NO.	REVISIONS NUMBER	BY	DATE
1	Submitted to the Town of Addison	CAC	07/26/07

**PRELIMINARY DRAINAGE PLAN**  
 (LOT 2, BLOCK A) RE-PLAT OF  
 BELTWOOD NORTH - AIRPORT ADDITION  
 TOWN OF ADDISON, DALLAS COUNTY, TEXAS

JOB NUMBER: 18-0701  
 SHEET NUMBER: 1

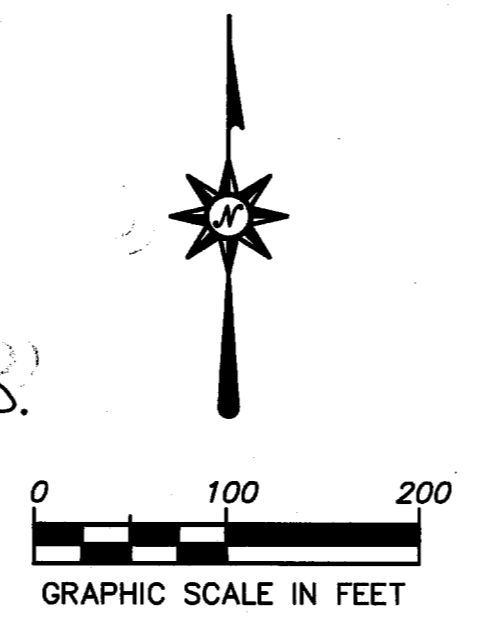
STORM SEWER SYSTEMS THAT CROSS LOTS WILL NEED A DEDICATED EASEMENT.

IF RETENTION IS NOT PROVIDED, A FLOOD STUDY OF HUTTON BRANCH FROM THE ELM FORK OF THE TROTON RIVER TO THE UPPER LIMITS WILL BE REQUIRED.
